**Proposed Minerals Extraction Scheme.
Bourbles Farm. Pilling.
Response to Highway Authority Consultation Response of 14 February 2025**

**Proposed Minerals Extraction Scheme.
Bourbles Farm. Pilling.
Response to Highway Authority Consultation Response of 14 February 2025
May 2025**

- 1.1 To avoid further protracted discussions on this application, this note provides a final response to the Highway Authority consultation response of the 14 February 2025 on the proposed mineral extraction scheme at Bourbles Farm, Pilling.

4. Visibility splay at access

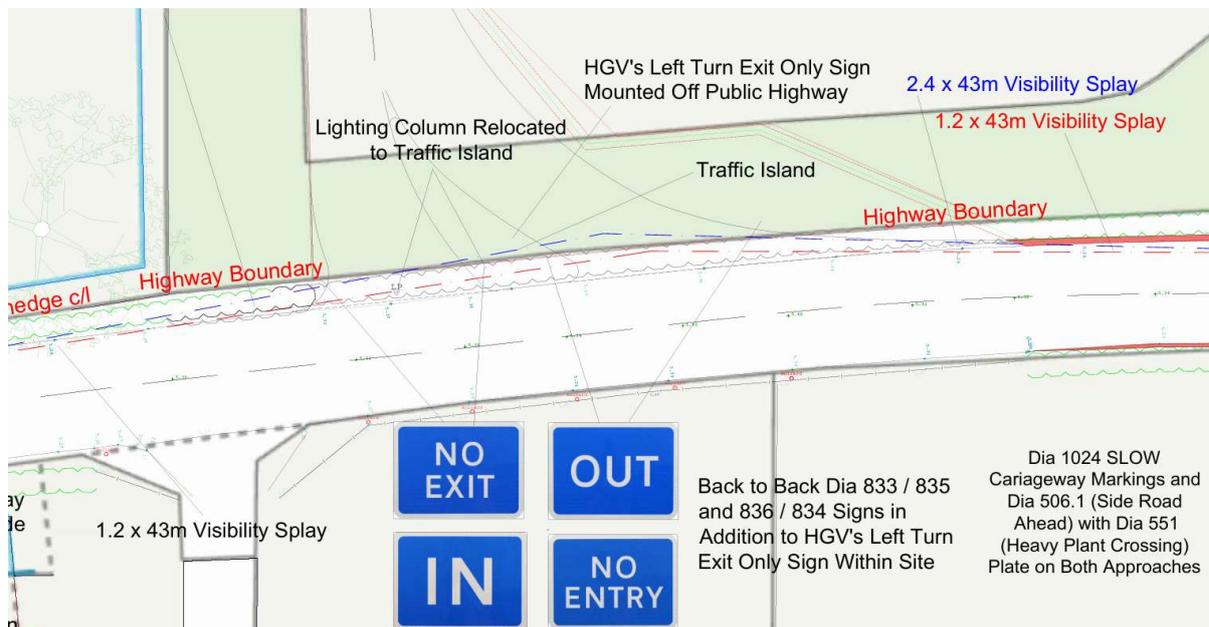
Prefer the carriageway being widened to its maximum than reducing the width any further.

Happy to accept 1.2m for HGVs.

- 5.8 At the second meeting (held on the 20/09/2024) the access was agreed. It has been shown in this agreed form since September 2024 with a 1.2 x 43m splay.

Effects on A588 at Fold House Farm

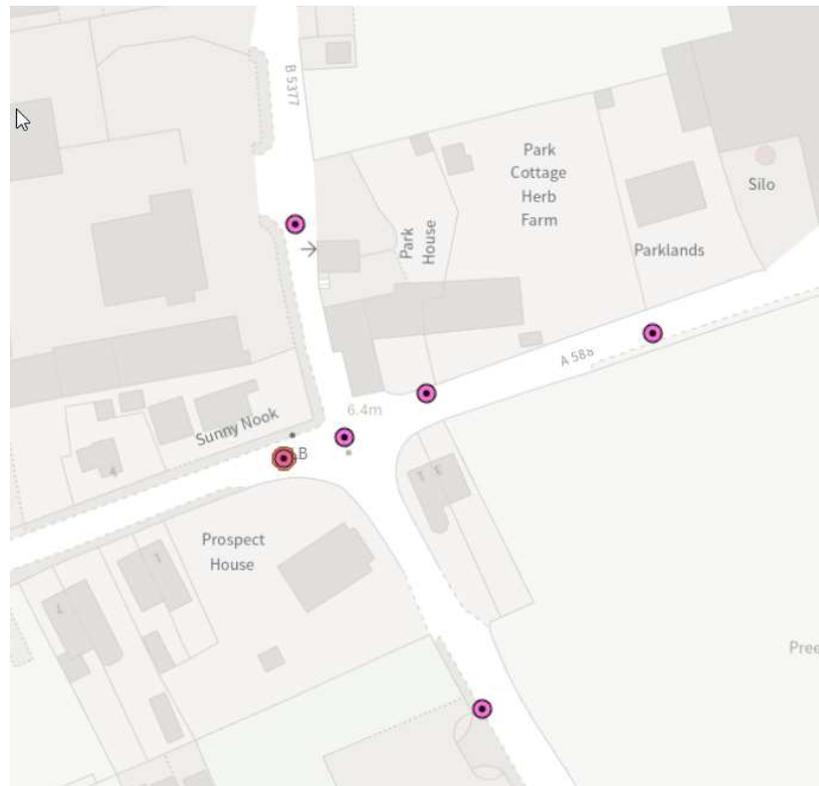
8.2 There have been no recorded accidents at this junction in the last 5 years. In fact the last recorded accident was in 2015 when two cars collided on the bend.

8.3 The applicant was requested to investigate this junction, despite there being no accidents identified in the search undertaken for the original Transport Assessment, at the second September 2024 meeting. It was suggested that signs indicating HGV's may approach in the centre of the road be provided as part of the development. These were then proposed as part of the development from thereon with the question of whether the signs could be provided within in the highway raised at the December 2024 meeting. The January 2025 Supplementary Information shows where the signs could be provided, all within the highway.

8.4 Had such signs been erected by the Highway Authority the 2015 accident may not have happened.
